From: John L <jhleete@frontiernet.net>
Sent: Saturday, February 21, 2015 1:49 PM
To: sherrie.thrall@almanorpost.com; Barnes, Peter@Waterboards; LACC Web Admin; sherrie.thrall@almanorpost.com
Subject: Caribou PH and penstocks
Attachments: GoogleEarth_Image.jpg; Fig 2-2.pdf

Figure 2-2 Observed and Estimated July 2002 (Dry Year) Water Temperature Profile along NFFR (Observed Average Mean Daily Temperature at BD1 (Belden Forebay) = 21.5°C)

From: John L <jhleete@frontiernet.net>
Sent: Tuesday, March 10, 2015 6:24 PM
To: sherrie.thrall@almanorpost.com; Barnes, Peter@Waterboards; Aaron Seandel; Alan Dubroff
Subject: Additional thoughts on passive thermal solution

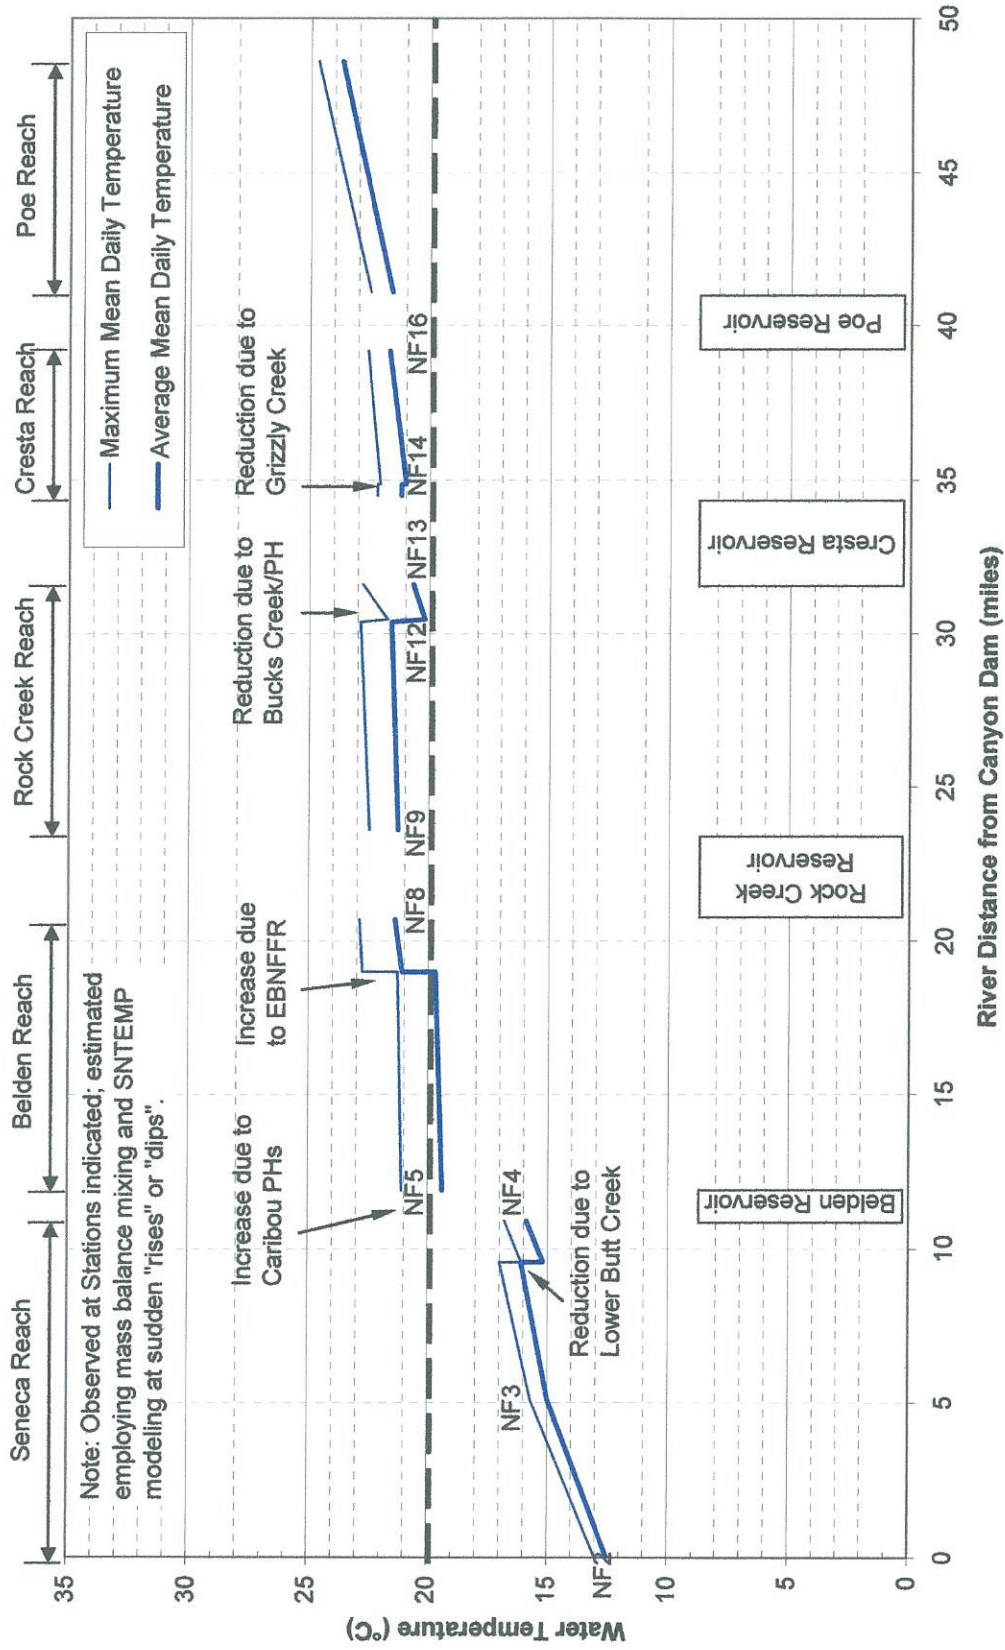
I have attached a copy of figure 2-2 from the Project No. 2105 Level 1 and Level 2 Report of 2007. It shows water average mean temperatures observed along the NFFR in July 2002, a dry year. A remarkable feature of the figure is a 4 deg.C increase of the water as it travels from the Butt Reservoir to the Caribou Power Houses. The figure also indicates that temperature at the end of the Poe Reach is 4 degrees above the goal of 20 deg.C. So if the water heating between the Butt Reservoir and the Caribou PH could be eliminated, it is possible that the goal would be satisfied. The water flows through tunnels that are a little less than two miles long and then through penstocks for about a half mile.

A Google Earth view of the penstocks that deliver the water to the Caribou #1 PH (power house) and the Caribou #2 PH is also attached. The view is looking North, so the penstocks are coming down a South-facing slope a few degrees West of due South. This is a bad orientation for exposure to direct radiation from the summer sun. In addition, some of the surrounding rock escarpment is light-colored and may also reflect heat onto the penstocks.

If the observed water heating is due to solar radiation, it should be relatively easy and cost effective to insulate the penstocks. This hypothesis can be easily tested by measuring the water temperature at each end of the penstocks on a hot sunny day.

John, I received your e-mail and have consulted with my engineers. The 4 degrees difference is primarily due to the fact that Prattville intake takes warmer surface water from Lake Almanor while the Canyon Dam outlet takes cold deep water from Lake Almanor. There is measurable water warming that occurs as the water travels through Butt Valley Reservoir (solar radiation adsorbed by reservoir surface area of 1600 acres or 69,696,000 sq. feet). The retention time for water traveling through Butt Valley Reservoir is 14 to 32 days depending on operating conditions.

Water flowing through the Caribou intakes (Butt Valley Reservoir) to the Caribou powerhouses (1&2) remains, for the most part, below the ground surface as it is conveyed in concrete lined tunnels (each about 1.7 miles long). This tunnel water

emerges above ground for an approximate distance of 0.35 miles (563.3 m) as it travels through the Caribou 1 and Caribou 2 powerhouse penstocks.

When underground, this water does not gain heat, rather the cooler ambient temperature of the rock surrounding the tunnels creates a situation where the conduit is a heat source, which loses heat to the cooler rock. So there may be a very slight decrease in water temperature as it travels through the tunnels.

When this water reaches the 0.35 mile long penstocks, during the period when the ambient air temperature is greater than the water temperature in the conduit, the surrounding air becomes the heat source and the penstock the heat sink. However, water temperature increases are miniscule as water moves through the penstock because:

1. Any particle of water is in the penstock for a very short period of time (i.e., ~ 56 s in Caribou 2 penstock), and

2. At any given time only a small volume of the water in the penstock is in close proximity of the penstock walls, as it travels through the penstock in ~56 s.

Given that the water travels through a much longer distance in the tunnels than penstocks, the small heat losses in the tunnel are likely to be larger than the small heat gain in the penstock, with a resulting net heat loss (albeit very small) as water travels from the intakes to the penstock outlet.

The travel time for water in the 563.3 m long Caribou 2 penstock can be calculated with the following information:

~ Average Diameter of Penstock = 2.86 m (90") (Note diameter ranges between 1.37 m to 3.20 m)

Flow rate = 41.46 m³/s (1464 cfs)

Velocity of Flow through penstock = $(4 * \text{Flow rate}) / (\pi * \text{diameter}^2) = 10.1 \text{ m/s}$

Travel time (Over 563.3 m) = 55.7 seconds
